ADDENDUM 2

Addendum #	2	**Date Issued**	Nov. 13th, 2026

Project Name | Job #	Bismarck Fire Station 6	20253510

1 G101 FIRST FLOOR LIFE SAFETY PLAN
1/8" = 1'-0"

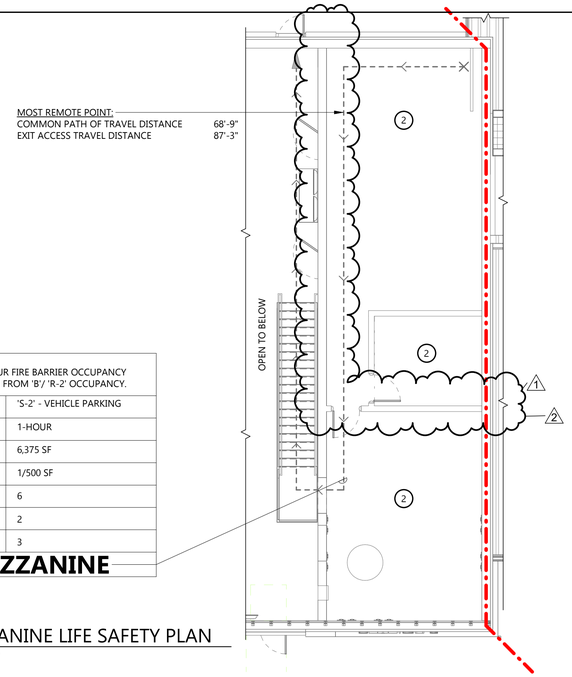
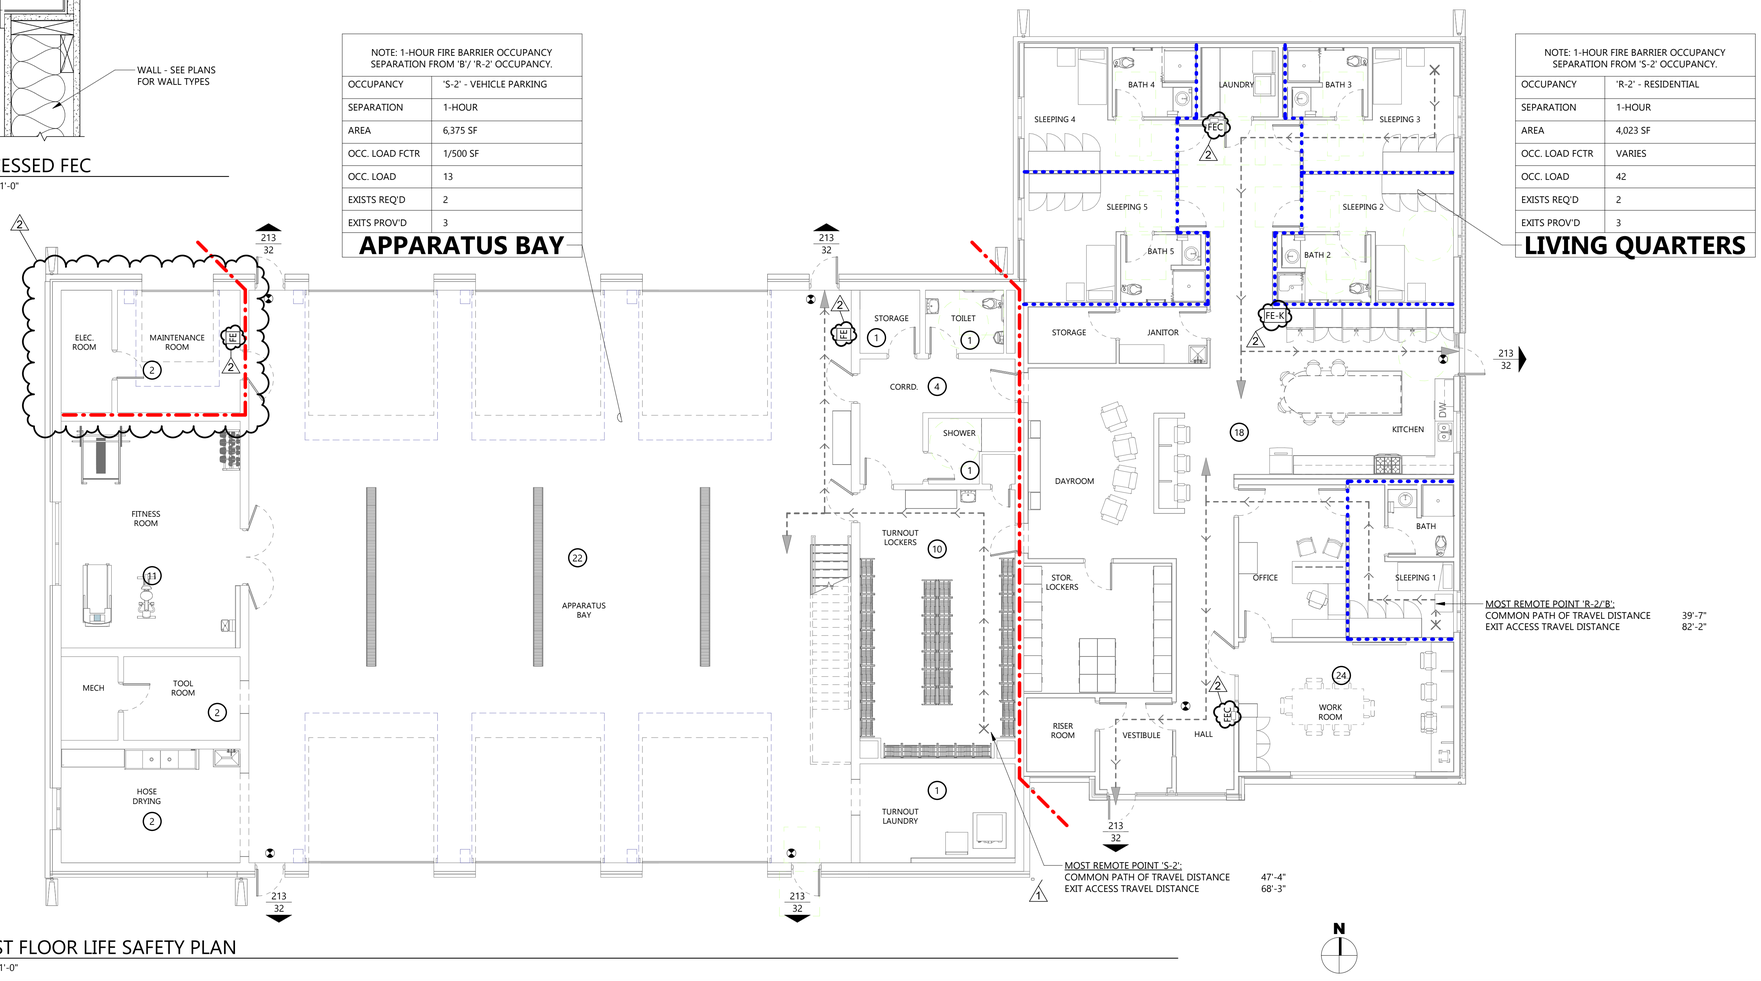
G101	**ADDED** Elec Room.
	ADDED Fire Extinguisher locations.
S001	**REVISED** Company awarded Geotech work.
	REVISED Top plate splice requirements for stud walls.
	ADDED Wood roofing construction requirements.
S002	**ADDED** Wood roofing design and material requirements.
S200	**REVISED** Schedules and OHD location.
	ADDED Keynote 2.
S201	**REVISED** Masonry pier schedule and Keynote 1.
	ADDED Keynotes 11-13 and CMU wall in equipment area.
S202	**REVISED** Living quarters framing and deck to be wood construction.
	REVISED Elevation callouts, schedules, and keynotes.
S203	**REMOVED** Second framing plan.
	ADDED Truss connection details and callouts.
	REVISED Truss diagram, keynotes, elevations, and masonry lintel schedule.
S301	**REVISED** Schedules, keynote 2, and plan.
S601	**REVISED** Details 3, 4, 6, 9, 11, 12, and 13.
S602	**REVISED** All details.
S701	**REVISED** Details 3, 4, 5, 6, 7, 8, 9, 10, 12, 13,14, and 15.

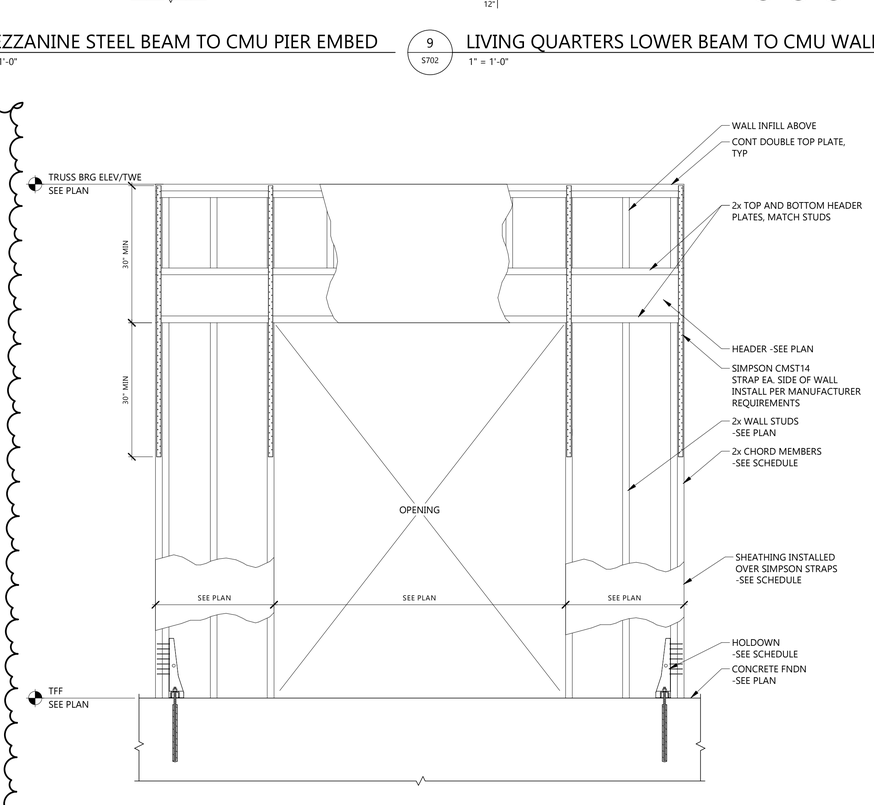
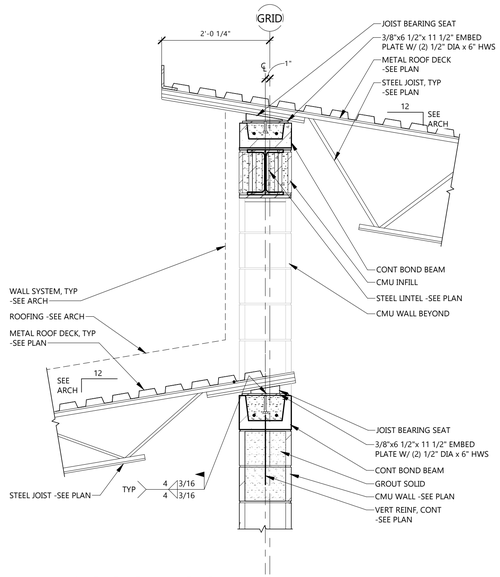
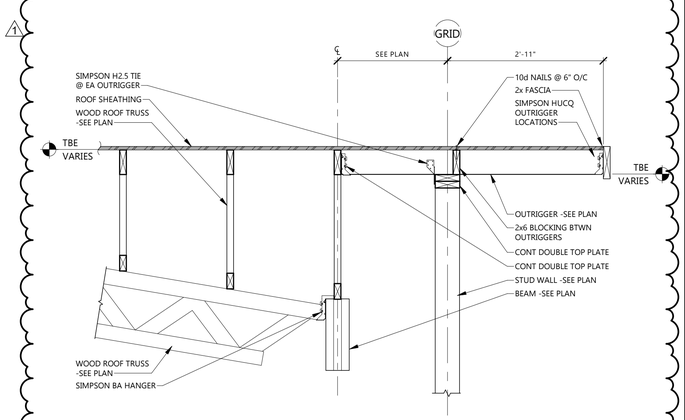
S702	**REVISED** Details 2, 3, 5, 6, 8, 9, 10, and 11.
S703	**REVISED** All details.
A003	**ADDED** details for trash enclosure.
A021	**ADDED** Roof type R2 for Living Quarter roof.
	REVISE Roof type R1, R-35 nail base insulation, PAC-Shield or sim.
	REVISED floor tag names.
	REVISED R Value for roof type R1.
A201	**ADDED** Elec. Room and Dr 135 in Maintenance Room 134.
	RELOCATED door 134B 2'-8" plan east.
	RELOCATED door 134A 2'-0" to plan north.
	REVISED Keynote AE02 detail reference.
A301	**ADDED** room 135.
A401	**REVISED** to EIFS reveal in 1/4A401 where OH Dr 134B has moved.
A421	**REVISED** roof detail.
A441	**REVISED** roof assembly notes updated.
A442	**REVISED** roof assembly notes updated.
A501	**REVISED** width of Shower Rm 124.
	CLARIFICATION furniture within Office 105, Contractor furnish Contractor install, owner selection during Appliance / Furniture allowance.
A601	**ADD** Detail 7/A601 – High App Bay Clearstory – Typical Detail.

1 / F201 FIRST FLOOR FIRE PROTECTION PLAN
1/8" = 1'-0"

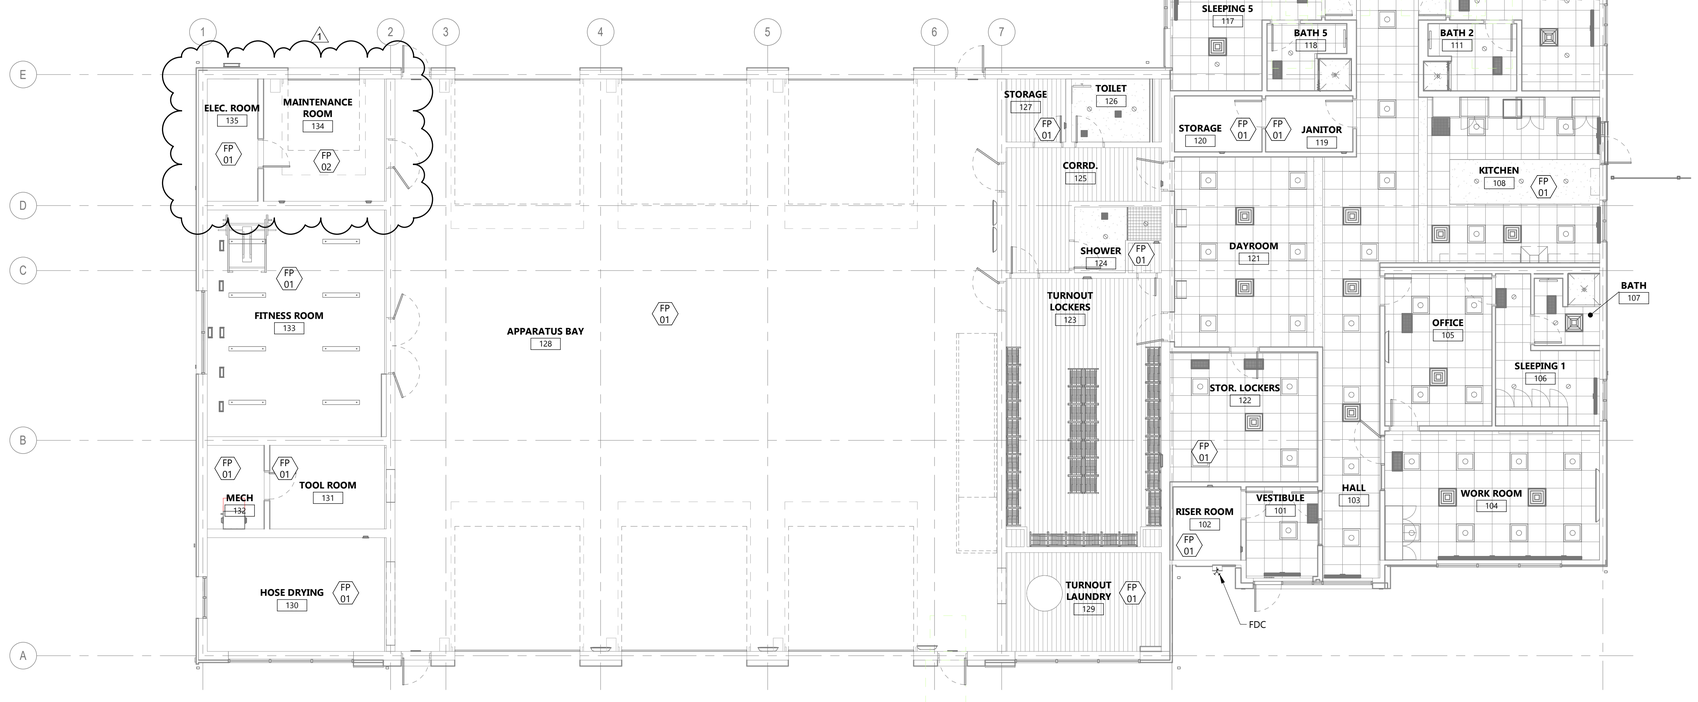
M802	**ADDED** to split system heat pump schedule.
F201	**ADDED** FP01 keynote to added elec. Room 135
P200	**ADDED** 2” waste line for floor drain, shifted waste piping for catch basin
P201	**ADDED** 2” floor drain
	ADDED 2” vent line for floor drain and 4” VTR
	REVISED CB-1 location

1 P203 ROOF PLUMBING PLAN

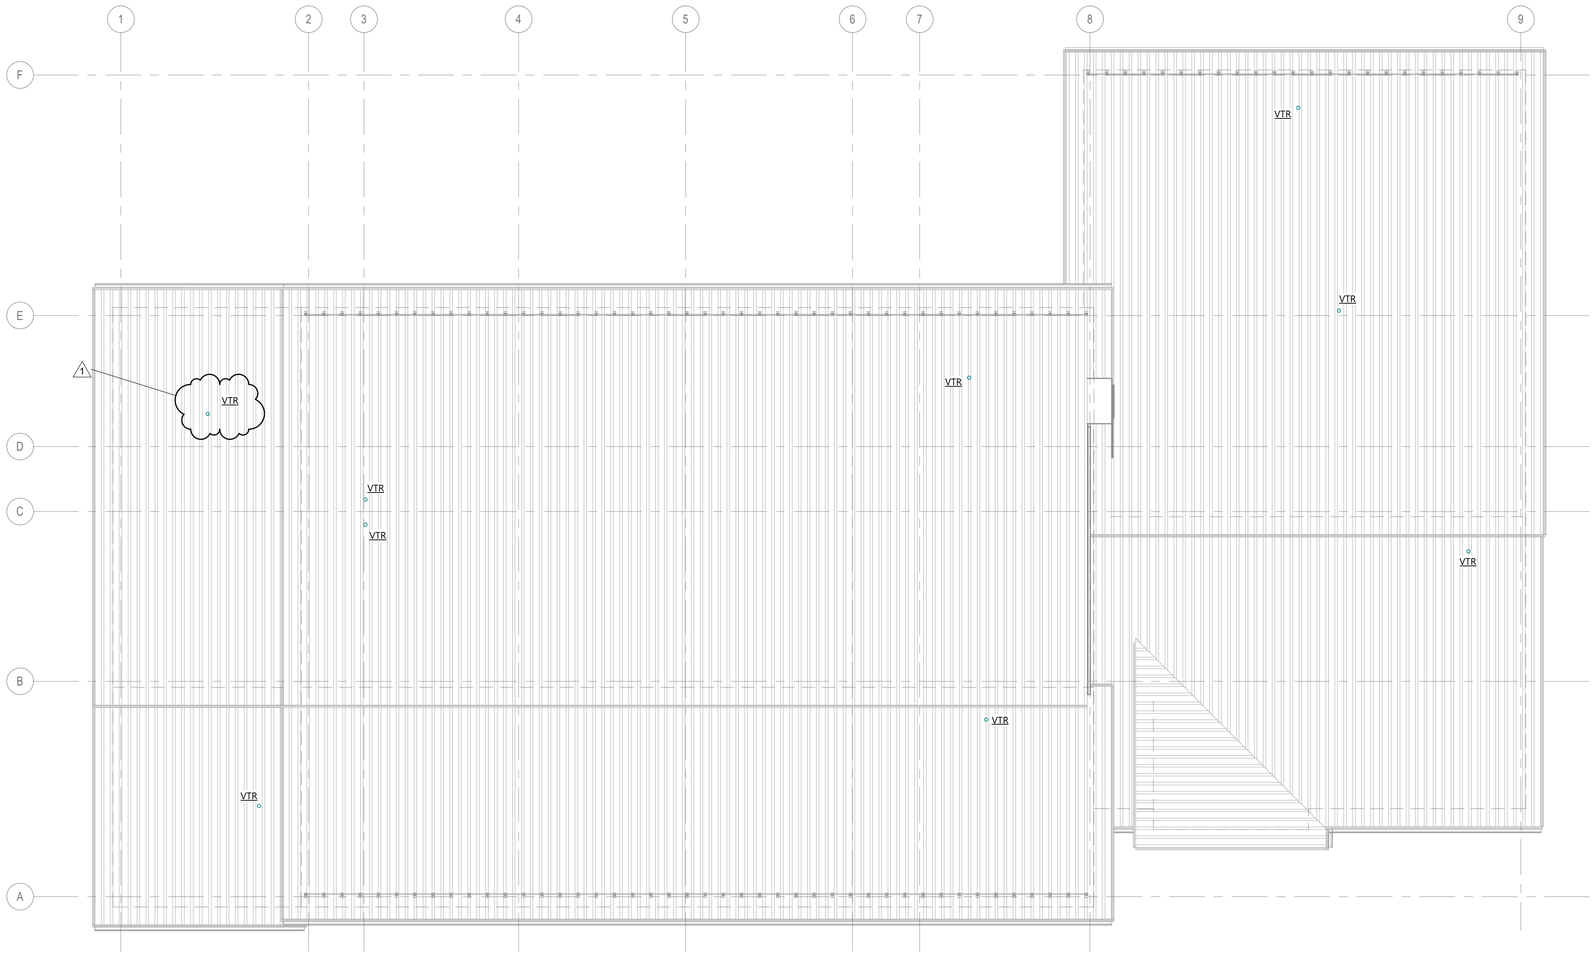
P203	**ADDED** VTR location on the roof
P501	**REVISED** Sanitary waste and vent riser diagram
E100	**ADDED** disconnects for ATS-1 and ATS-LS to site plan.
	ADDED additional Type BB light to the site plan.
	REVISED light pole layout on site plan.
E100A	**REVISED** light fixture schedule, statistics, and photometric calcs.
E201	**ADDED** ACCU-4 to power plan.
	REVISED service entrance equipment with new electrical room.
	REVISED location of GUH-3.
E301	**REVISED** lighting layout with new electrical room.
E501	**REVISED** fire alarm device layout with new electrical room.
E801	**REVISED** disconnects for ATS-1 and ATS-LS to include NEMA 3R rating.
	REVISED ATS-LS voltage to 208V.
E802	**ADDED** ACCU-4 and AC-2 to Motor Riser and Motor and Equipment schedule.
E803	**REVISED** exterior light fixtures AA and BB.
	REVISED exterior light fixture DD wattage label.
E901	**ADDED** ACCU-4 to Panel Schedule L1.

1 M801 MECHANICAL FLOW DIAGRAM
NOT TO SCALE

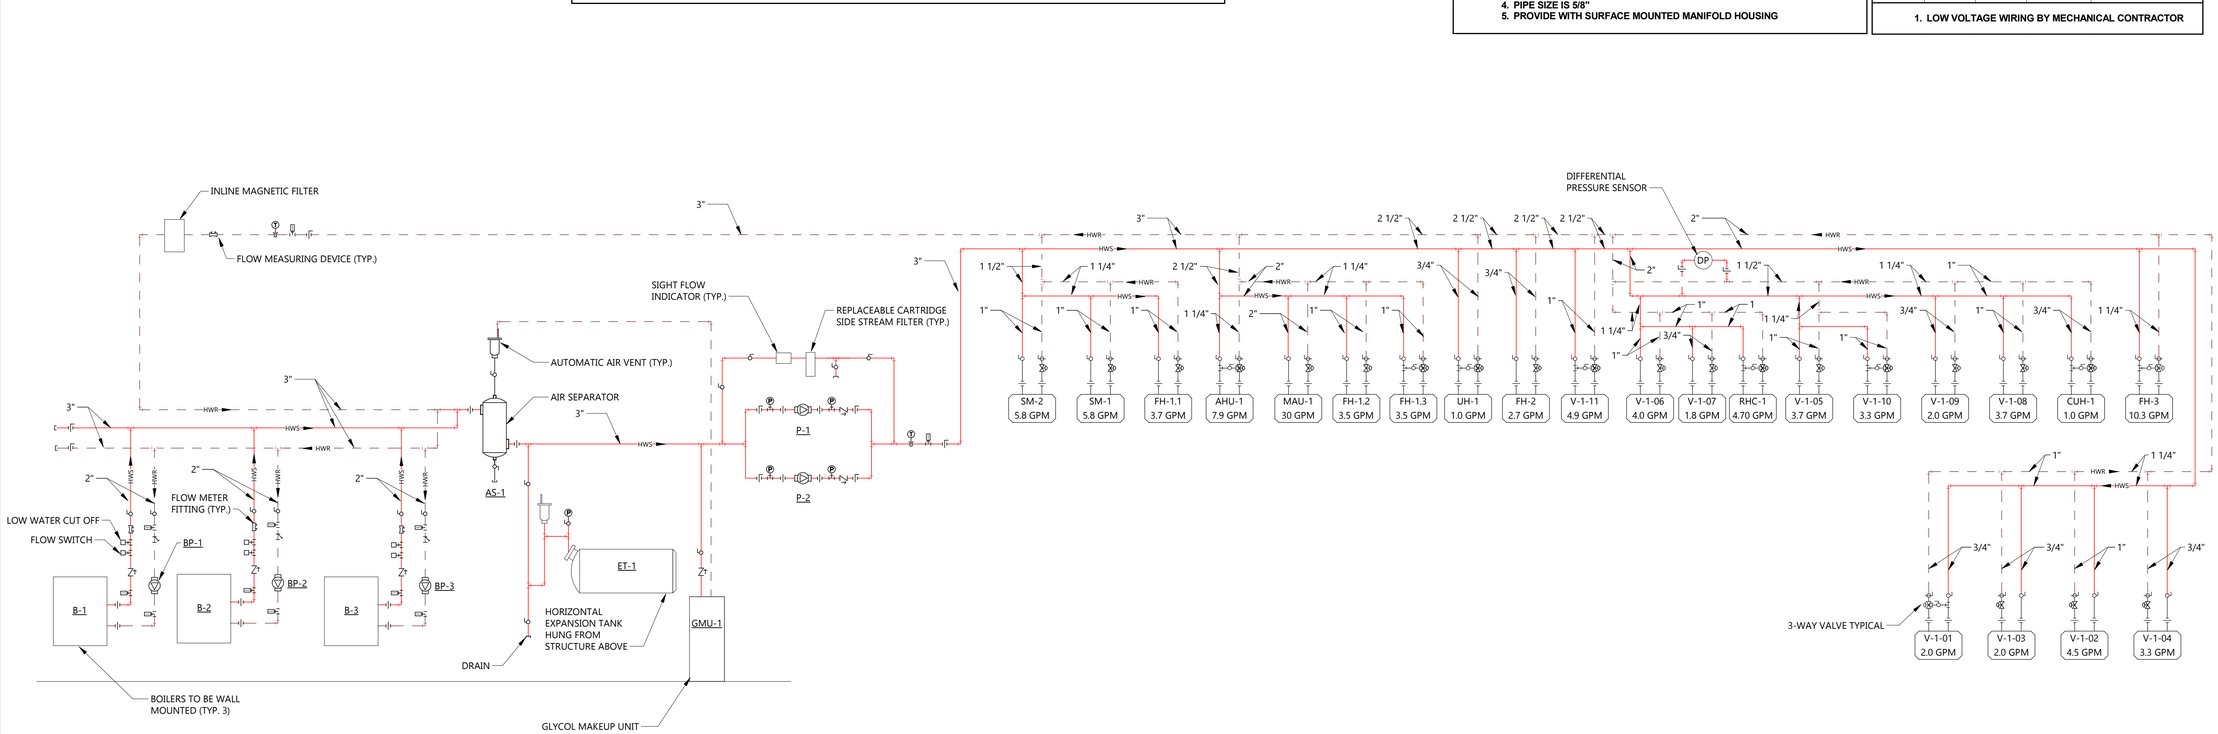
A703	**REVISE** Keynote AE 34: Stainless Steel Table, Contractor furnish Contractor install, owner selection during Appliance / Furniture allowance
	REVISE Keynote AE 43 (all sheets): CONCEALED METAL COUNTERTOP SUPPORT, Iron Supports, Hidden Granite Countertop L Bracket – 22”, every 36” of countertop
	REVISE Keynote AE 48: FITNESS ROOM EQUIPMENT, OWNER PROVIDED BY ALLOWANCE 1 – See Spec.
	ADD NOTE Detail 11/A703 – Gypsum board wall to be capped with 5/8” gyp. bd. Paint and texture to match face of wall
A801	**REVISED** door frame types. Hm-02 added.
	REVISED door schedule.
A901	**REVISED** general note 28.
	REVISED 1/A901 to show location of window shades.
M201	**ADDED** AC-2 and ACCU-4 for new Electrical Room.
	REVISED GUH-3 location and associated thermostat and piping.
M301	**REVISED** EF-2, L-2, and GUH-3 locations and associated ductwork.
	REVISED MOD-1 size.
M801	**REVISED** motorized damper schedule.
